NO.	DATE	ISSUED FOR	BY
2	03/02/2020	ADDENDUM	GAB
1	01/21/2020	BID SET	GAB

CITY OF HALLANDALE BEACH UTILITIES DEPARTMENT
PRODUCTION WELL PW-9
STAGING PLAN

Proposing firms must provide this Addendum # 2 form signed by an authorized officer of the firm to acknowledge receipt of ADDENDUM # 2. The form must be provided with firm's response.

DATE: FEBRUARY 2020
SHEET: 20 OF 42
DRAWING: M-04

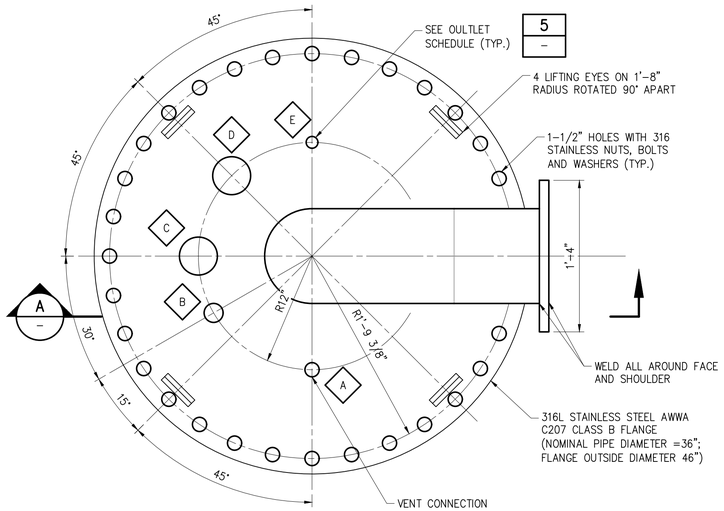
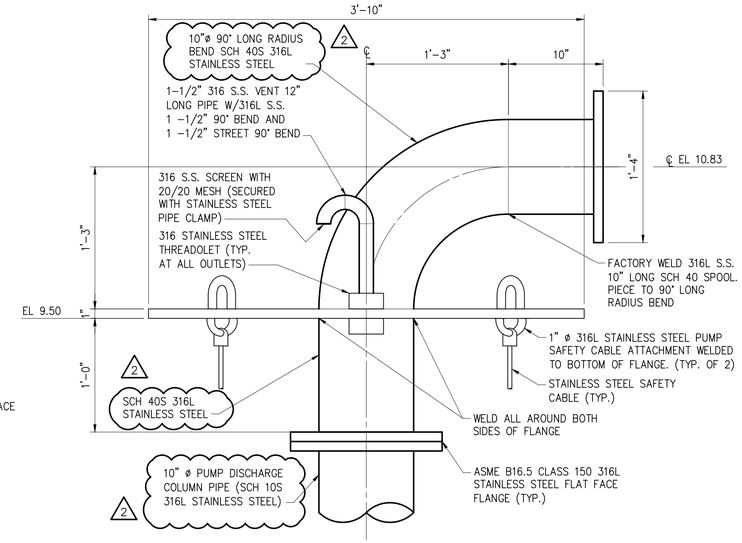
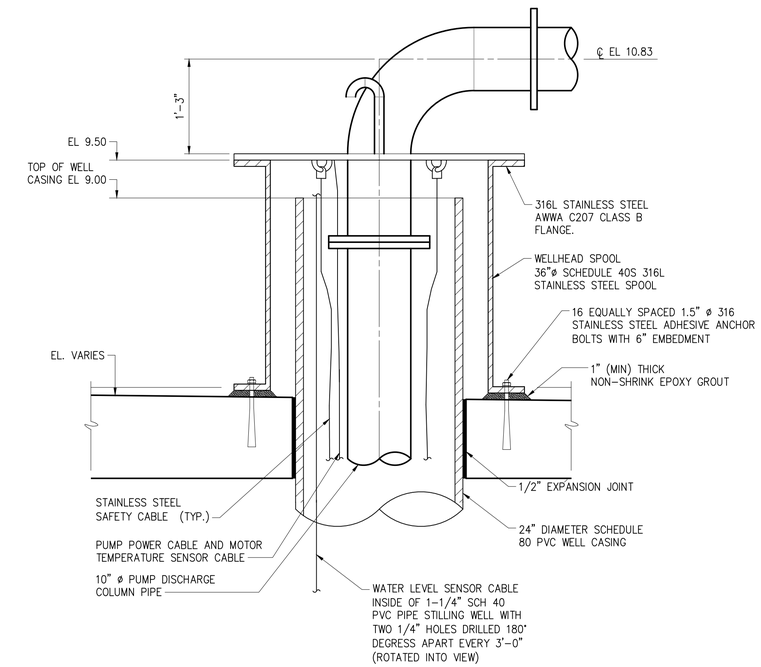
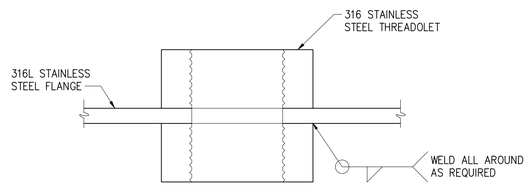
QUESTION #12.
Note 2 on M-04 says all pipe shall be schedule 40 but M-02 calls out the 10" drop pipe as schedule 10. Please confirm schedule of the drop pipe.

ANSWER # 12.
See revised drawing M-04 issued with this addendum.

DATE: FEBRUARY 2020
SHEET: 39 OF 42
DRAWING: I-02

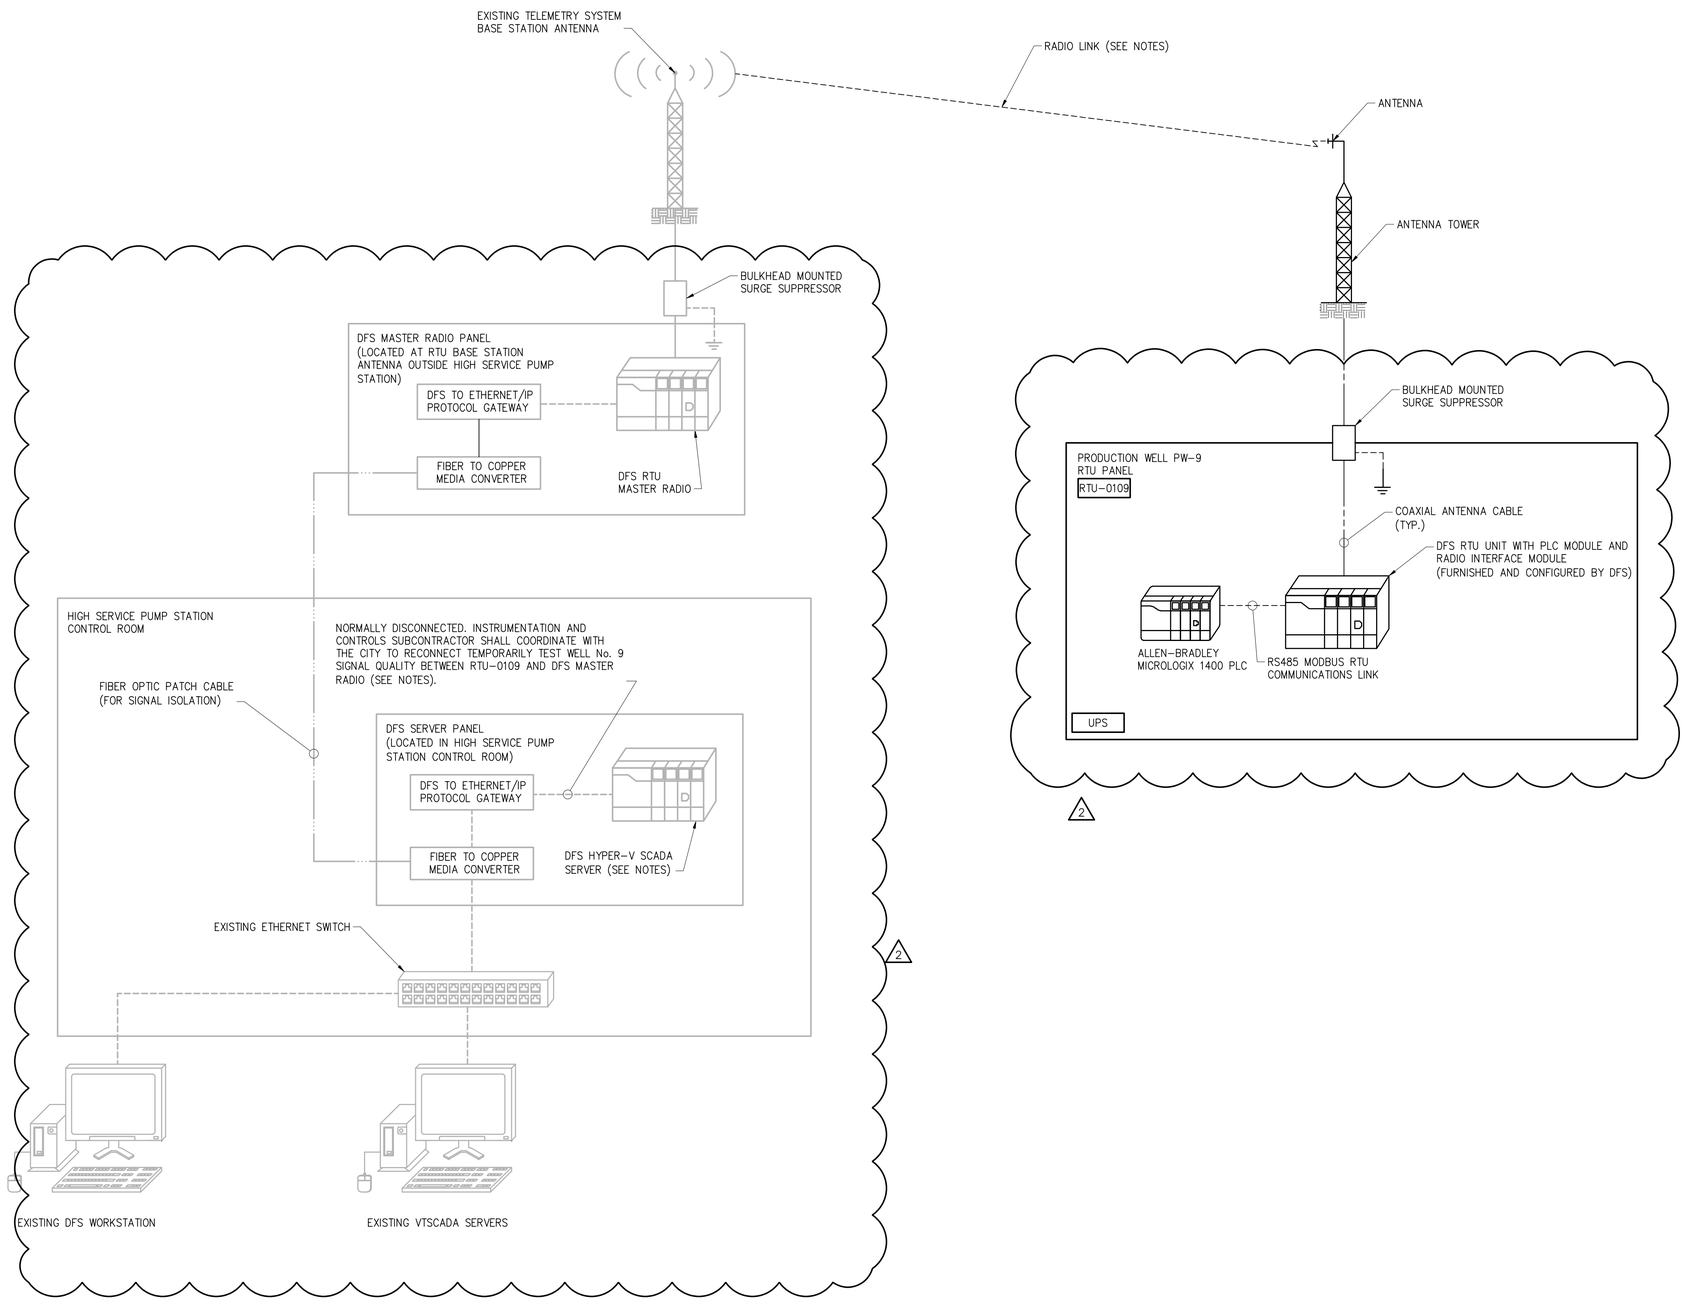
QUESTION #16.
VT SCADA computer/software is shown on diagram, DFS does not provide services for VT SCADA. A separate I & C subcontractor will need to be acquired to provide services on VT SCADA.

QUESTION #17.
What work, other than station configuration, is to be done on the DFS SCADA server?

QUESTION #18.
It is noted (17000 1.01 C 4) that the RTU is expected to contain a MicroLogix 1400 PLC. DFS does not provide, install, service or support non-DFS automations system. DFS cannot maintain our warranty and service obligation using third party automation devices. DFS has used 1400 PLC as protocol converters, but not for site primary automation. With this said, DFS will not be providing the 1400 PLC within the RTU and a separate I & C subcontractor will need to be acquired to provide these services:

a. Who is expected to provide the PLC and Programming?
b. Where is the PLC expected to be located, outside the RTU?
c. A DFS PLC must be in the RTU in order to communicate with the MicroLogix via a protocol, <u>the native industrial protocol DFS can use to communicate will be Modbus.</u>

QUESTION #19.
As DFS will only be providing the RTU and not be providing the Automation System. The specification will need to call for DFS to be the "RTU provider" responsible for Section 17132 only. A separate Instrumentation and Control System Subcontractor will need to be called out to provide the instrumentation, PLC and other services outside section 17132.

1. RTU-0109 RADIO TOWER SHALL BE FURNISH AND INSTALLED BY CONTRACTOR.
2. RTU-0109 RADIO ANTENNA, ANTENNA CABLE, SURGE SUPPRESSOR AND ALL REQUIRED ACCESSORIES SHALL BE FURNISHED AND INSTALLED BY INSTRUMENTATION AND CONTROLS SUBCONTRACTOR.

3. DFS (DATA FLOW SYSTEMS) SHALL UPDATE EXISTING FCC RADIO LICENSE AS REQUIRED TO INCLUDE THE DFS RADIO IN RTU-0109 IN THE CITY'S DFS NETWORK.
4. DFS SHALL FURNISH A DFS RTU UNIT WITH A PLC MODULE WITH BACKPLANE, POWER SUPPLY/UPS, RADIO MODULE AND CABLES REQUIRED TO COMMUNICATE WITH THE INSTRUMENTATION AND CONTROLS SUBCONTRACTOR FURNISHED ALLEN-BRADLEY MICROLOGIX 1400 PLC. THE UNIT SHALL BE SHIPPED BY DFS TO THE INSTRUMENTATION AND CONTROLS SUBCONTRACTOR A MINIMUM OF 2 WEEKS PRIOR TO FACTORY TESTING OF RTU-0109.

ANSWER # 16.
See revised Technical Specification Sections 17000 and 17132 issued with this addendum. See revised drawing I-02 issued with this addendum.

ANSWER # 17.
See revised Technical Specification Sections 17000 and 17132 issued with this addendum. See revised drawing I-02 issued with this addendum.

ANSWER # 18.
See revised Technical Specification Sections 17000 and 17132 issued with this addendum. See revised drawing I-02 issued with this addendum.

See revised Technical Specification Sections 17000 and 17132 issued with this addendum. See revised drawing I-02 issued with this addendum.
